**TOWN OF BAY HARBOR ISLANDS
MORRIS N. BROAD COMMUNITY CENTER
1175 95TH STREET
BAY HARBOR ISLANDS, FL 33154**

DEVELOPMENT & REVIEW COMMITTEE MEETING

**TOWN OF BAY HARBOR ISLANDS
COMMUNITY DEVELOPMENT
MEMORANDUM**

Subject: Site Development Plan Application
1085 Townhouses – 6 DU Townhouse Complex
1085 94th Street
Bay Harbor Islands Acct. No. SPR24-000025
MMPA Account No. 01-0702-1197

SCALE 1/8" = 1'-0"

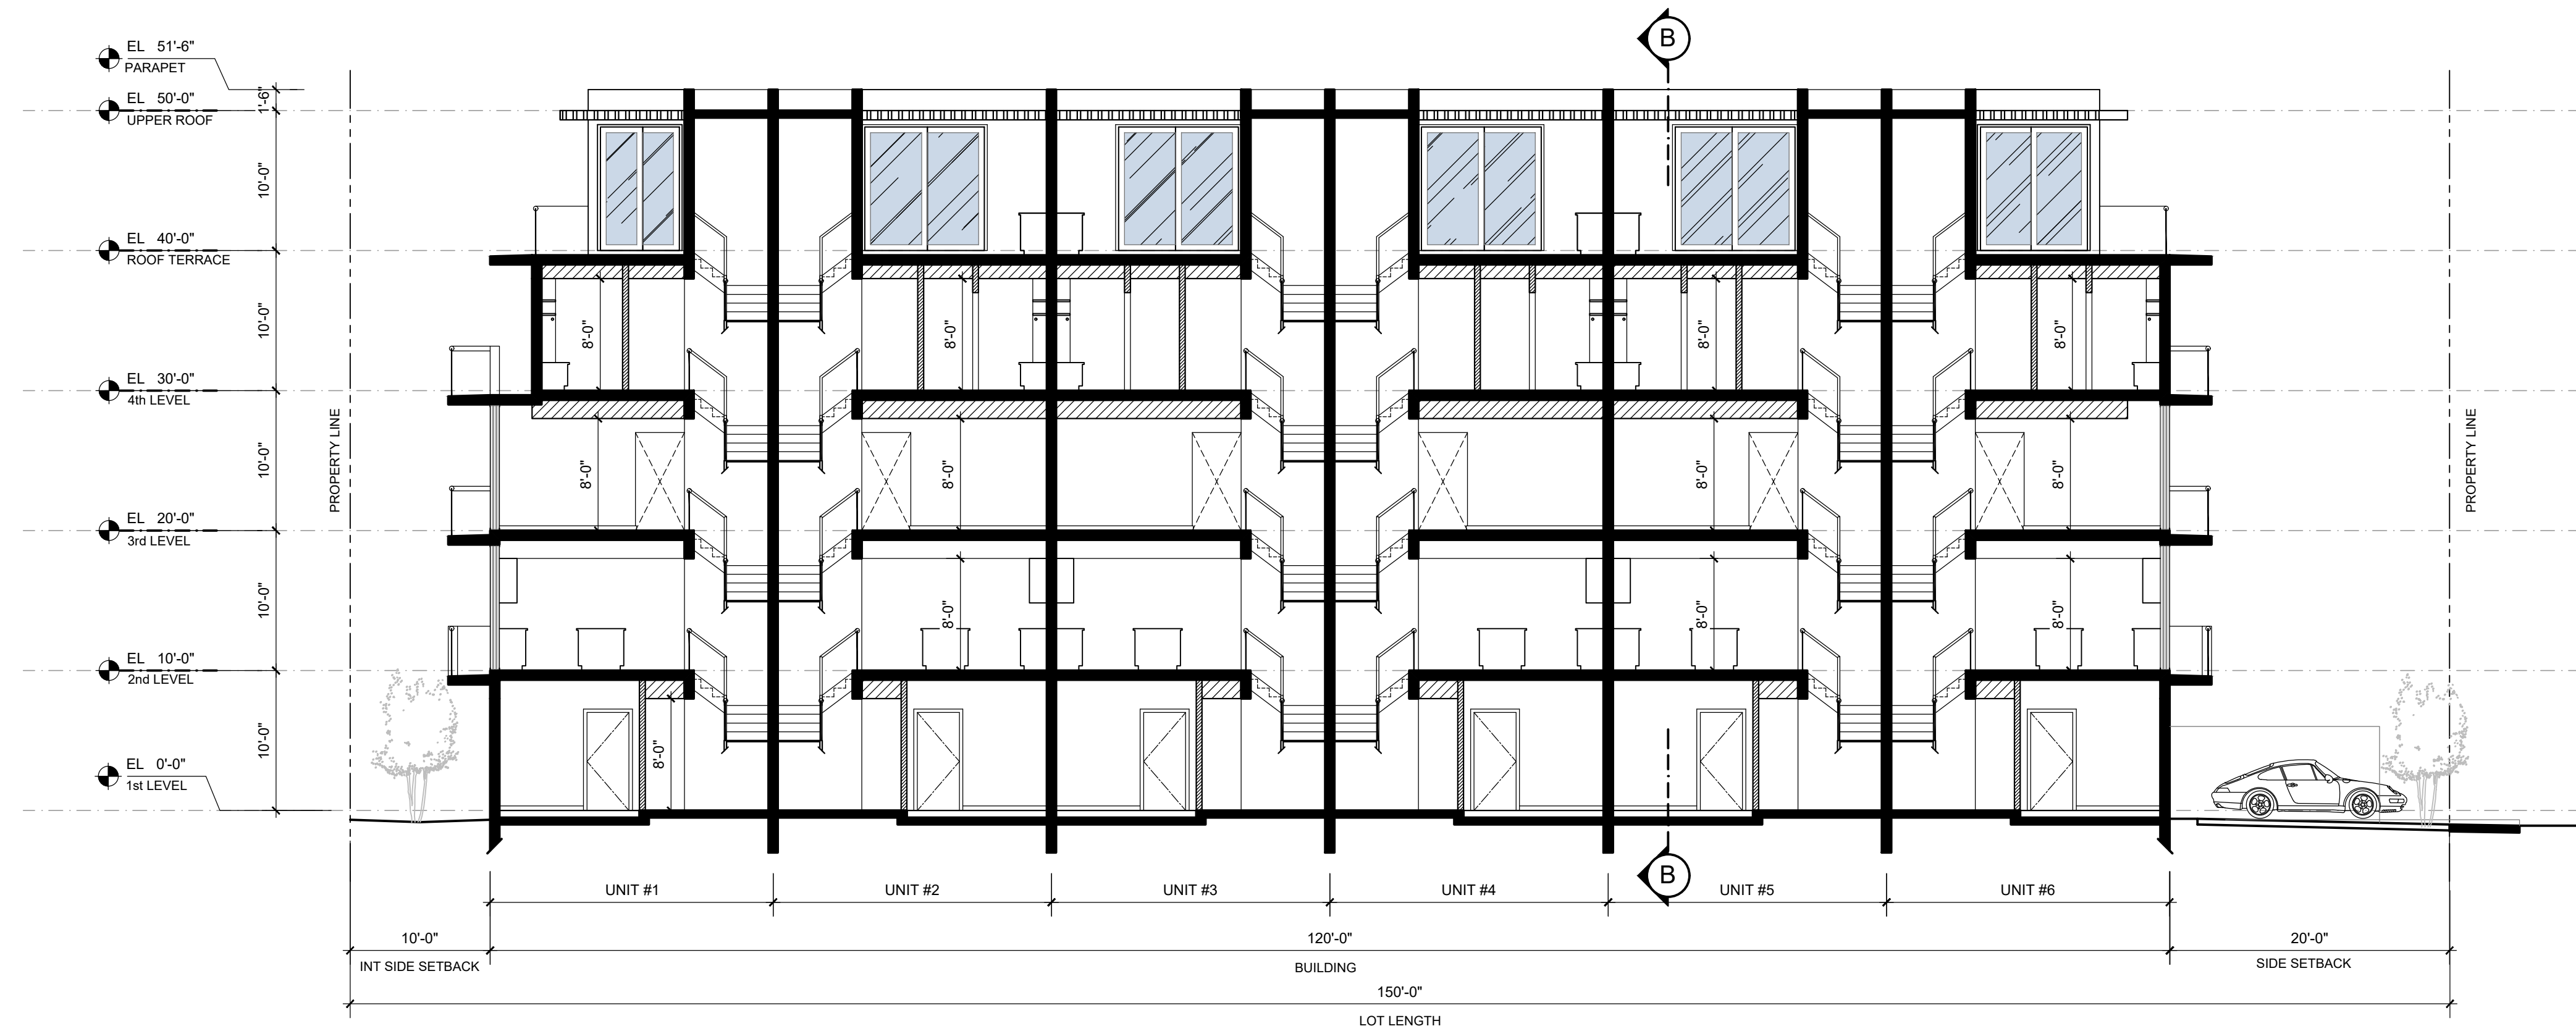
- 2) All elevation plans must label the Base Flood Elevation (BFE) + 1' FBC freeboard for each building elevation.
- 3) Elevation Sheet A-3 / others does not scale to 1/8" = 1'-0". Please check and revise.

A BUILDING SECTION

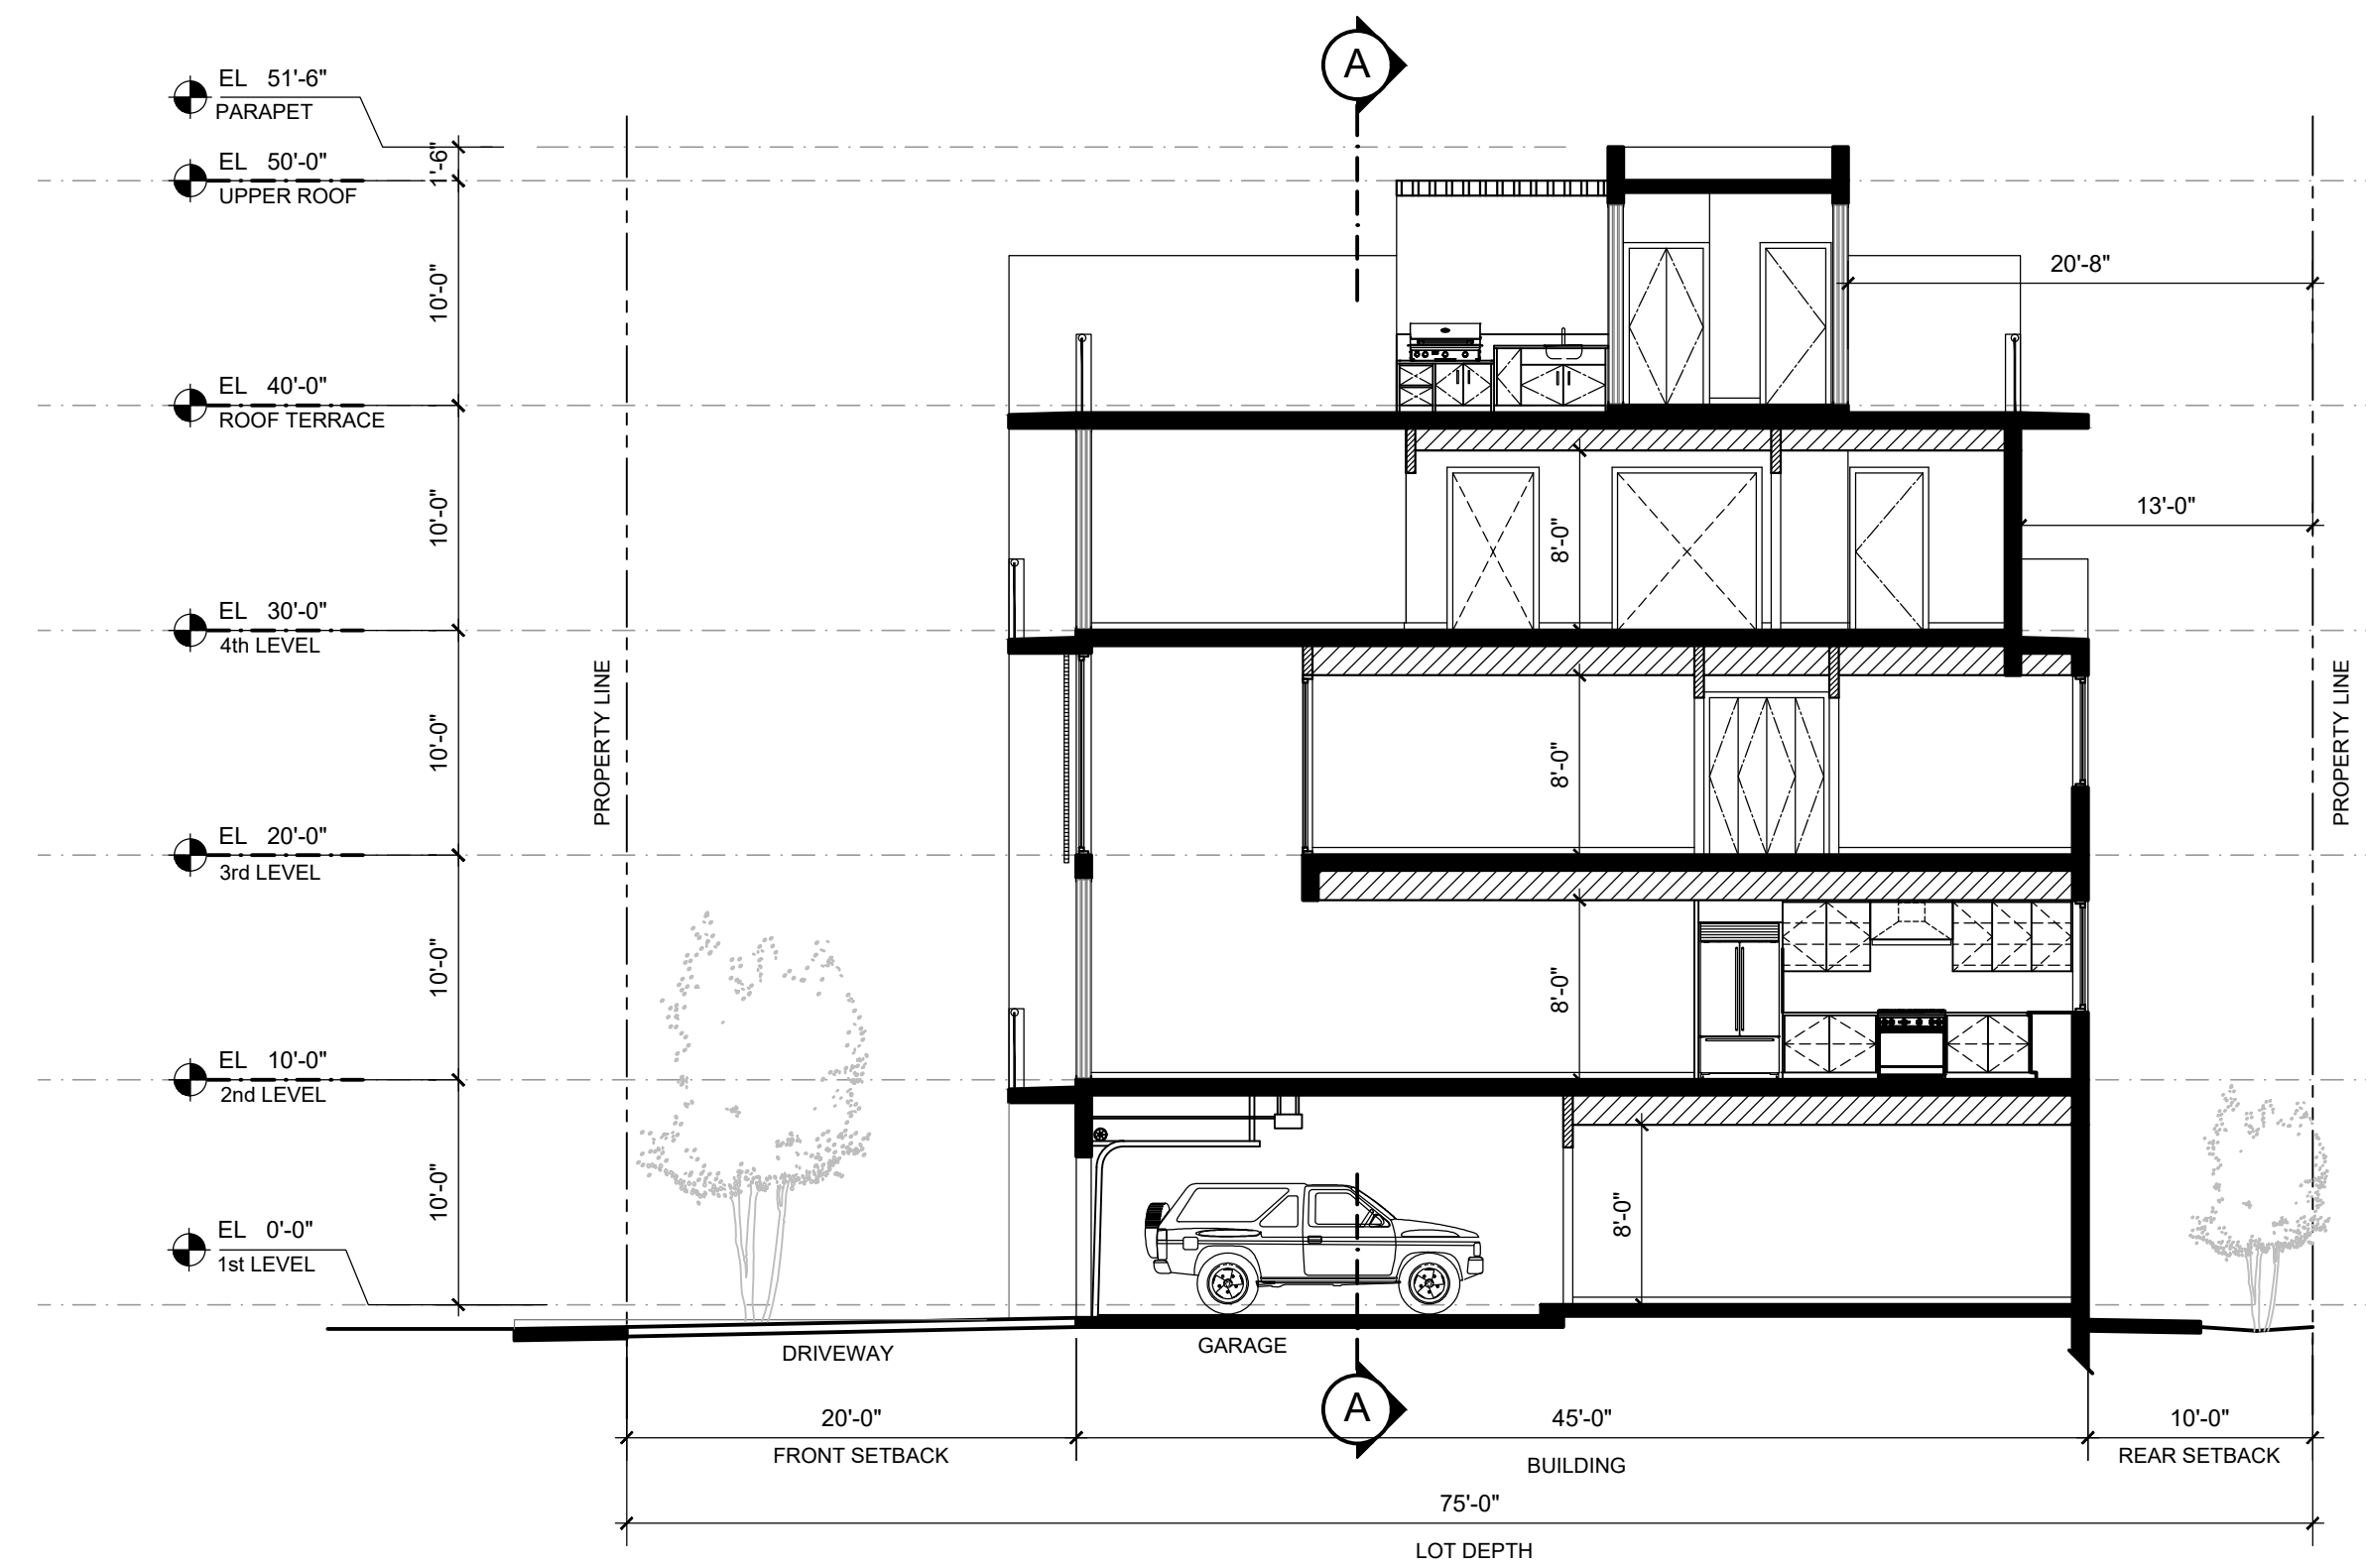
- 6) Sheet A-4 Building Section shows a floor to ceiling height of 8'. The Code minimum is 9' from the top of one floor slab to the bottom of the floor slab above it. Please revise.

- 13) On Sheet A-4 Building Section “B” needs to be revised to show the correct front yard setback for portions of buildings over 30 feet in height (25' setback).
